Re: Peach Bottom Atomic Power Station Units 2 and 3
Docket Nos. 50-277 and 50-278

APPLICATION FOR AMENDMENT
OF
FACILITY OPERATING LICENSES
DPR-44 & DPR-56

APPLICATION FOR AMENDMENT
OF
FACILITY OPERATING LICENSES
DPR-44 & DPR-56

PEACH BOTTOM ATOMIC POWER STATION - UNITS 2 AND 3

FIGURE 6.2-1

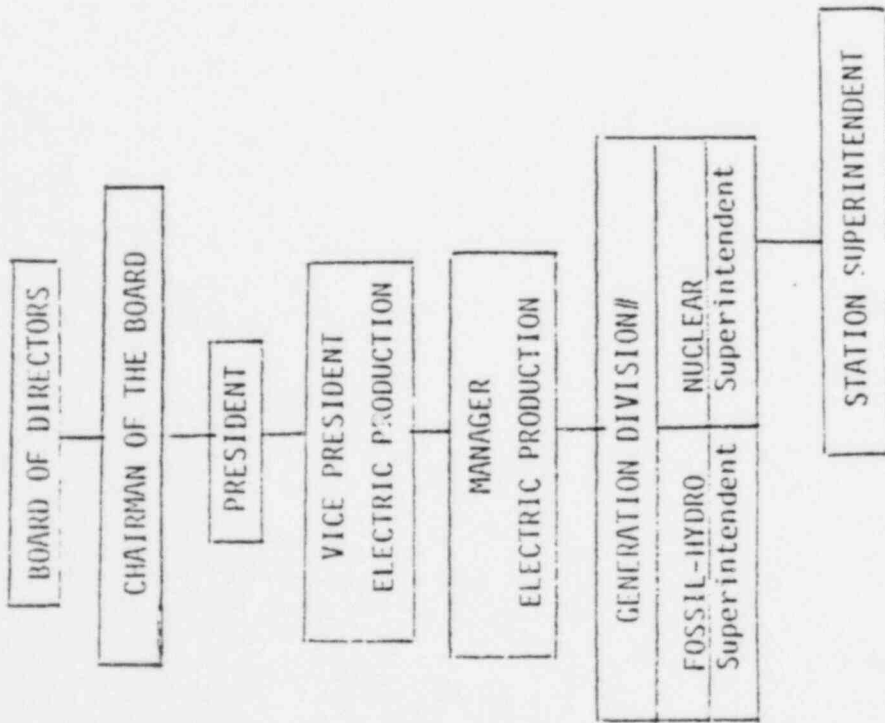
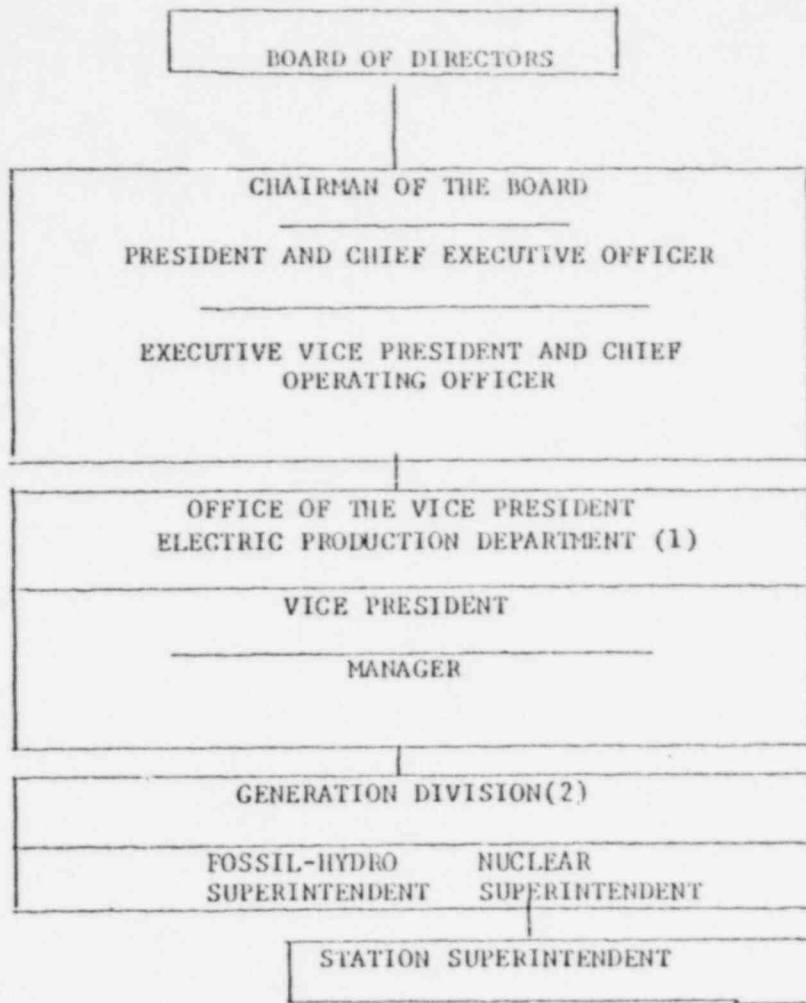
Philadelphia Electric Company, Licensee under Facility Operating Licenses DPR-44 and DPR-56 for Peach Bottom Units 2 and 3, hereby requests that the Technical Specifications contained in Appendix A of the Operating Licenses be amended by revising certain sections as indicated by a vertical bar in the margin of attached pages 234f, 234n, 234o, and 243, and by the addition of revised Figure 6.2-1 on page 244.

The proposed modification of the Management Organization Chart (Figure 6.2-1) reflects changes designed to provide for more effective control of company operating activities at the

executive levels of management. The reorganization assigns the responsibility of Chief Operating Officer to the Executive Vice President. The Office of Vice President - Electric Production Department reports directly to the Chief Operating Officer. Additionally, Philadelphia Electric Company requests procedural changes to section 6.2.1 (page 243) that would streamline the administrative process required for future revisions to the Management Organization Chart presented in the Technical Specifications.

6.2.1 The offsite organization for facility management and technical support shall be as shown on Figure 6.2.1. Revisions to Figure 6.2.1 may be implemented without a prior License Amendment provided that a revised Figure 6.2.1 is included with the next License Amendment request.

ORGANIZATION FOR CONDUCT OF
PLANT OPERATIONS

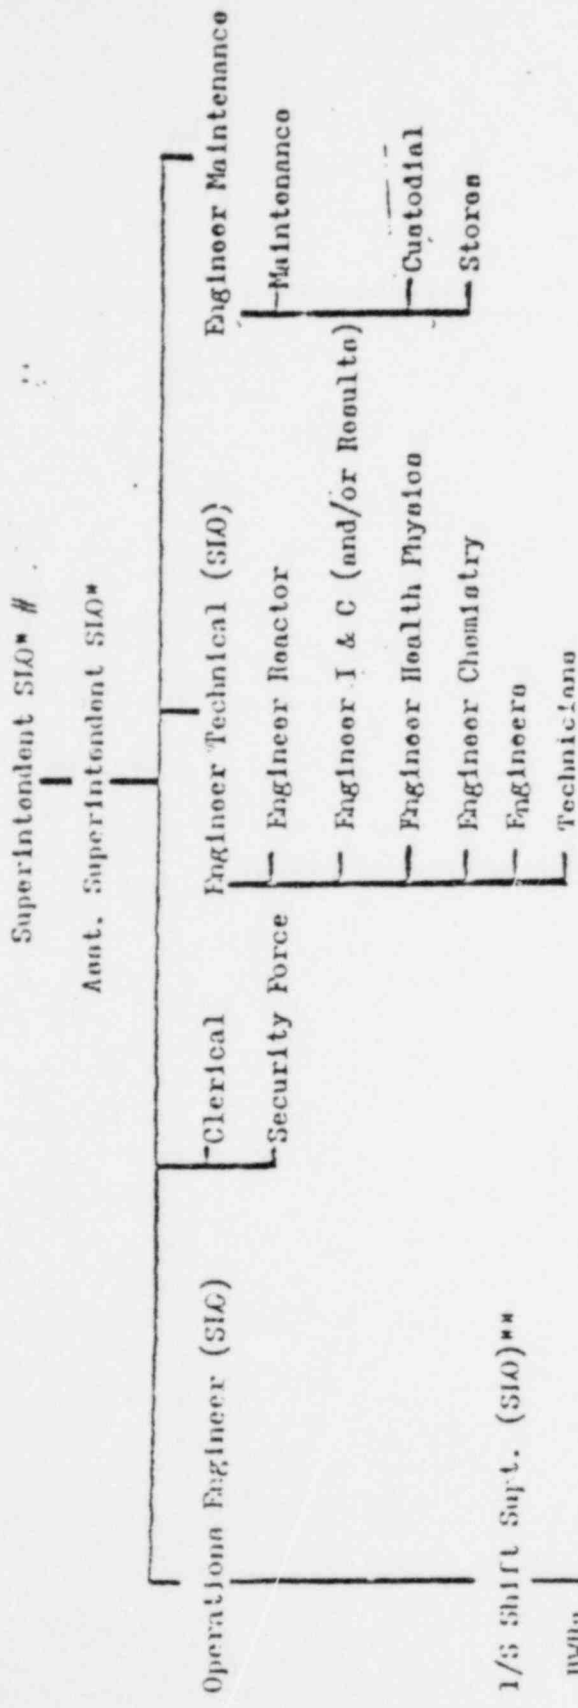
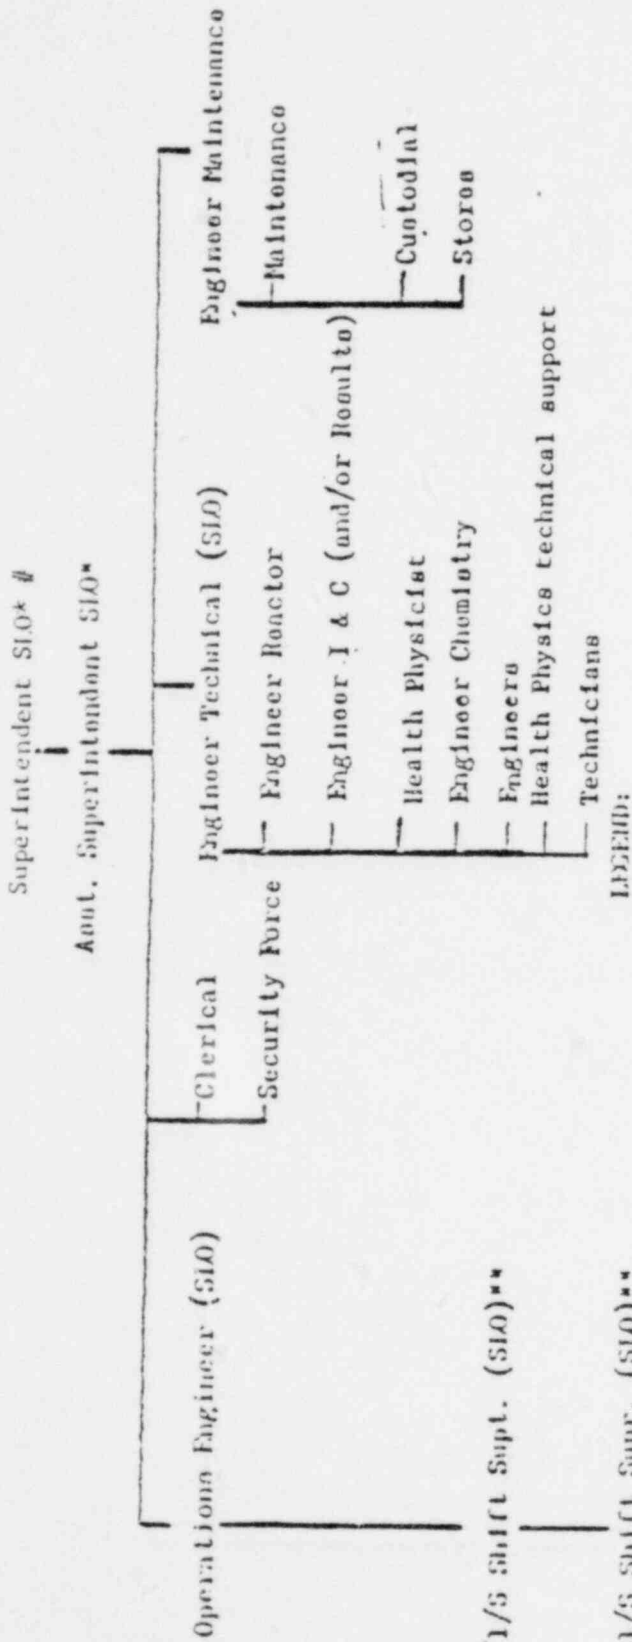
The Peach Bottom Atomic Power Station Radiation Protection organization was recently revised to accommodate the resignation of the incumbent Engineer - Health Physics, as described in a letter from M. J. Cooney, Philadelphia Electric Company to B. H. Grier, NRC, dated May 2, 1980. The revision involved changing the title "Engineer - Health Physics" to "Health Physicist." As described in our May 2 letter, the person

Filling the position of "Health Physicist" meets the qualification requirements of Regulatory Guide 1.8, September 1975. We proposed that the organization for conduct of plant operations as described in Figure 6.2-2, and the composition of the Plant Operation Review Committee stipulated in section 6.5.1.2, be modified to reflect this change. Coincident with this change, we further propose that the organization as described in Figure 6.2-2 be modified to reflect a minor reorganization. This involves the creation of a new group, providing support to the Peach Bottom Health Physics organization in certain technically oriented activities required by the Radiation Protection Program. The group would be directed by a person with a bachelor's degree in engineering or a related science.
